NOTICE OF DECISION

CLASS 3 SITE PLAN REVIEW / CLASS 2 ADJUSTMENT / CLASS 2 DRIVEWAY APPROACH PERMIT / CLASS 1 DESIGN REVIEW CASE NO.: SPR-ADJ-DAP-DR24-35

SUMMARY: A proposal for a new 135-unit multi-family housing development.

IN THE MATTER OF APPROVAL OF	) FINDINGS AND ORDER
CLASS 3 SITE PLAN REVIEW,	)
CLASS 2 ADJUSTMENT,	)
CLASS 2 DRIVEWAY APPROACH PERMIT	)
AND CLASS 1 DESIGN REVIEW,	)
CASE NO. SPR-ADJ-DAP-DR24-35	)
5871 LIBERTY ROAD S	) FEBRUARY 12, 2025

STORAGE 1 (11 STORAGE)

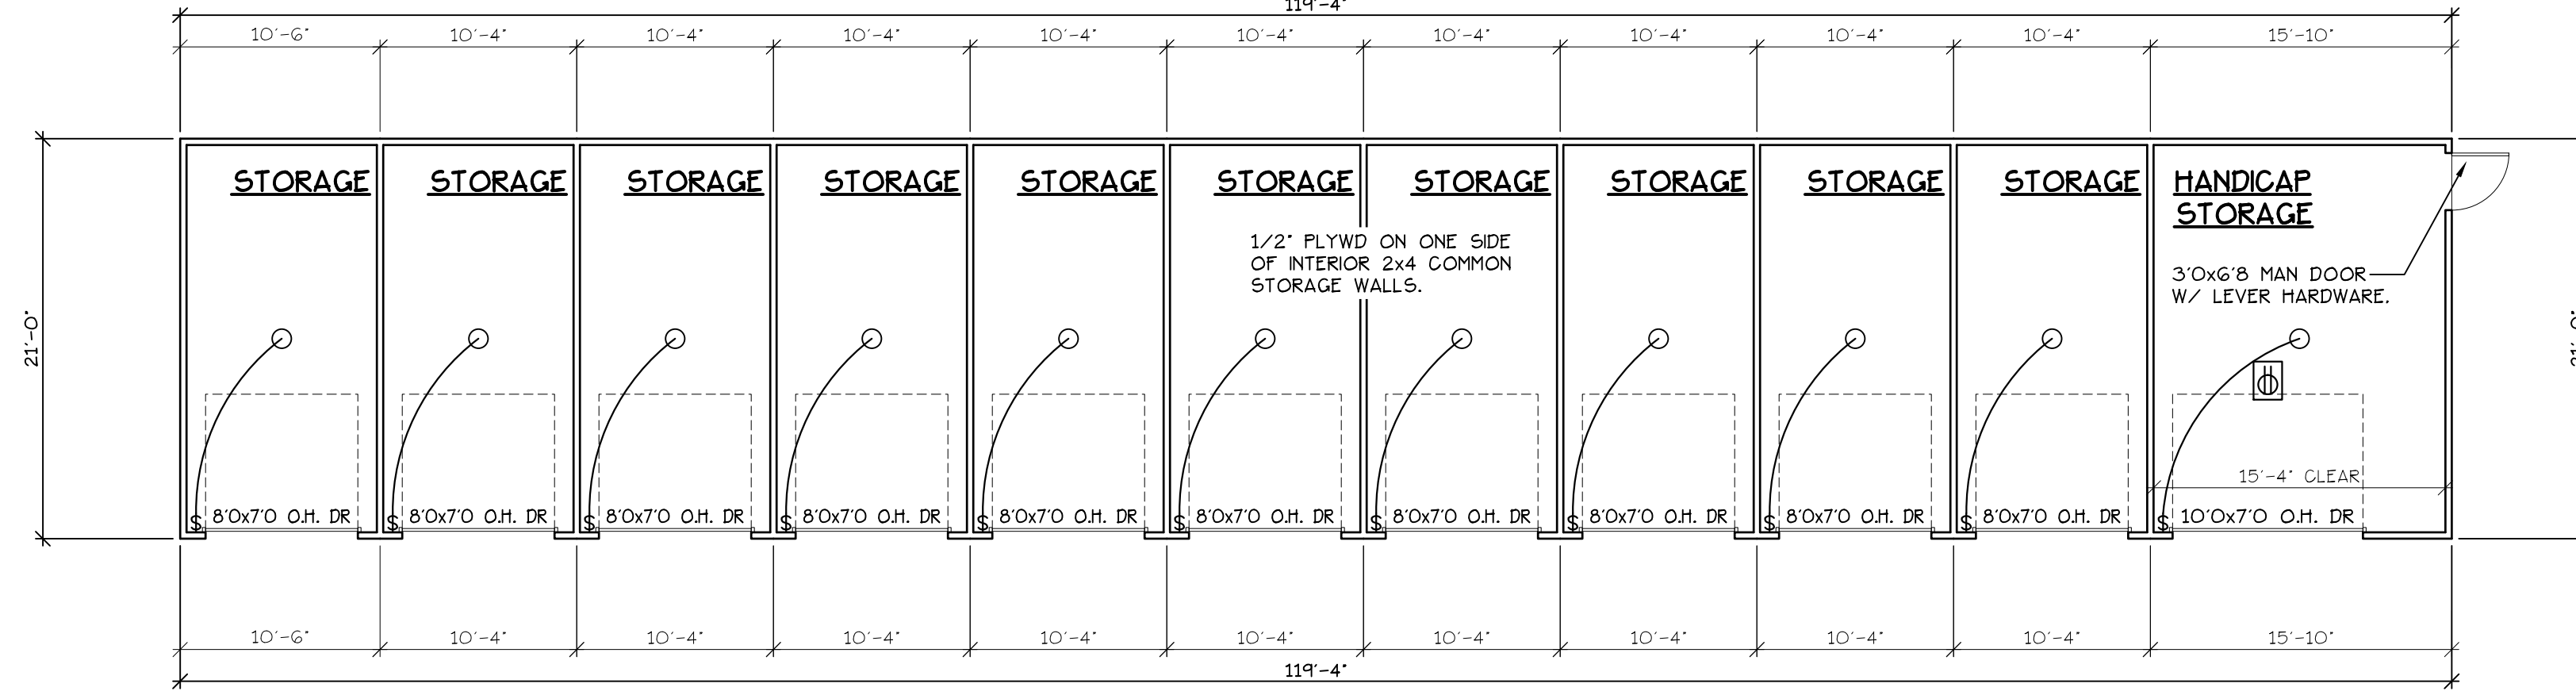
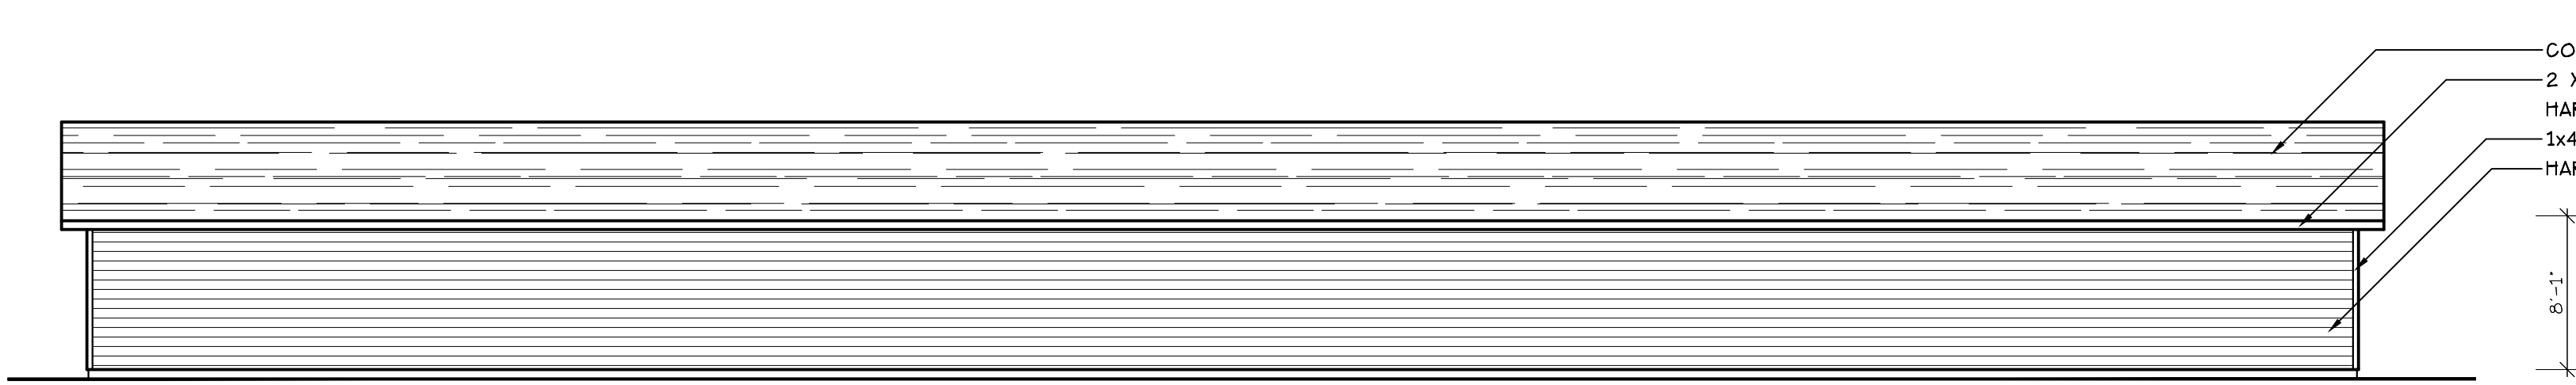
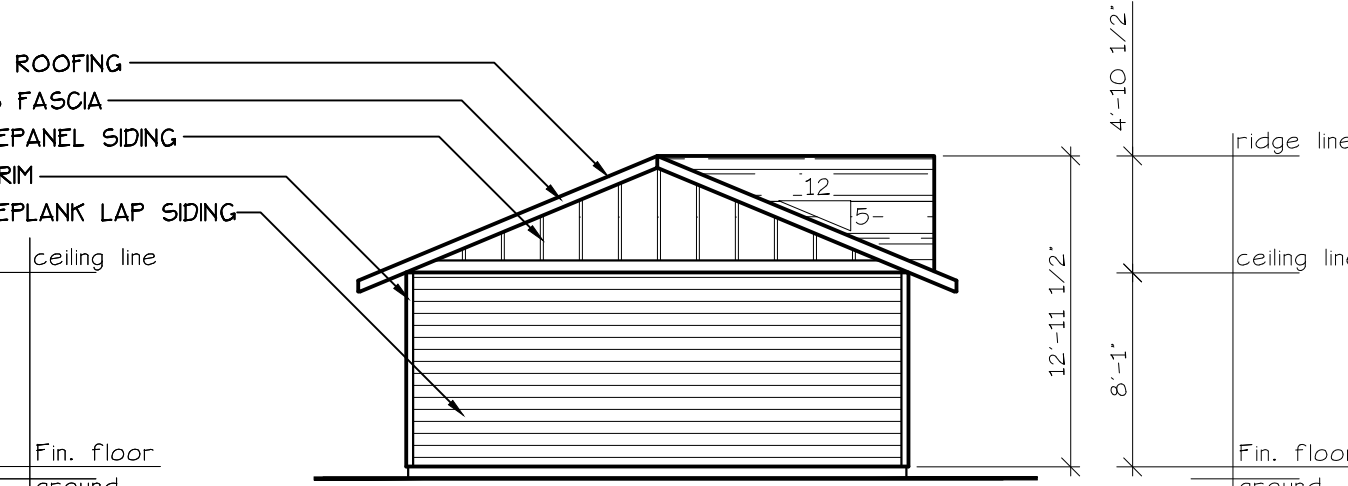
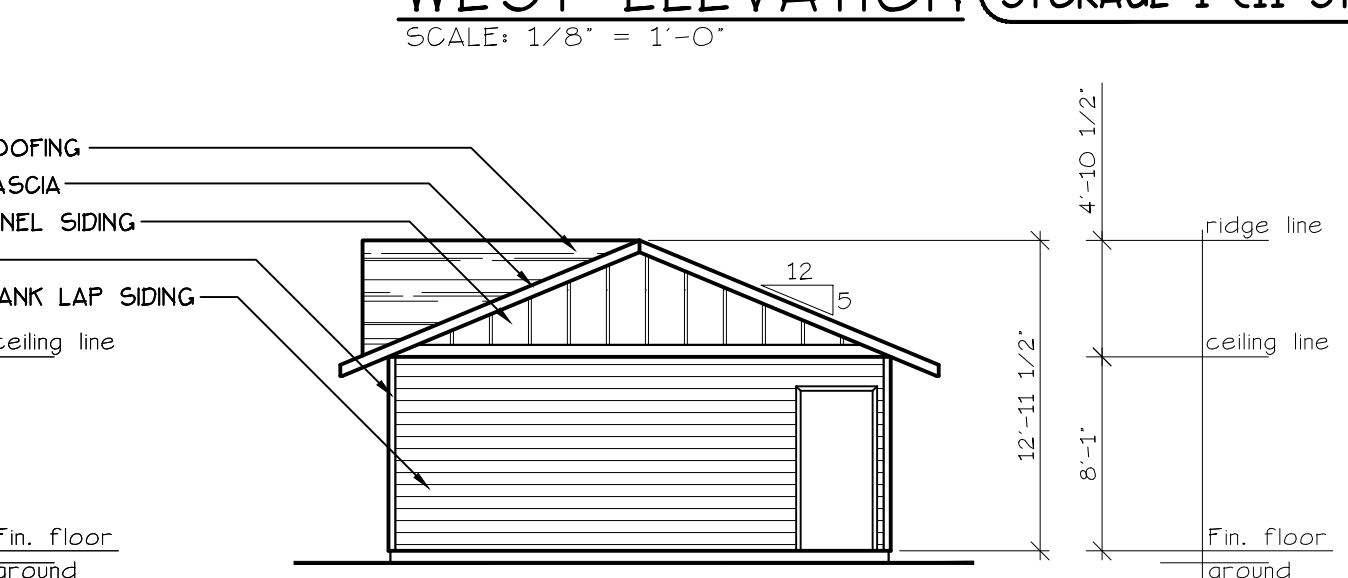
- Condition 4:** At the time of building permit review, the width of the roll-up doors for the storage units shall be reduced in size so that a vehicle, compact or otherwise, cannot fit into the storage space.

Condition 24: At the time of building permit review, each of the storage buildings north of Eagle Dance Street S shall be revised to incorporate at least one design element as set forth in SRC 702.020(e)(9), or obtain approval of a Zoning Adjustment to use an alternative design element to break up the vertical face of the buildings, including but not limited to, alternative siding, faux windows, or gable roofs.

- Condition 24:** At the time of building permit review, each of the storage buildings north of Eagle Dance Street S shall be revised to incorporate at least one design element as set forth in SRC 702.020(e)(9), or obtain approval of a Zoning Adjustment to use an alternative design element to break up the vertical face of the buildings, including but not limited to, alternative siding, faux windows, or gable roofs.
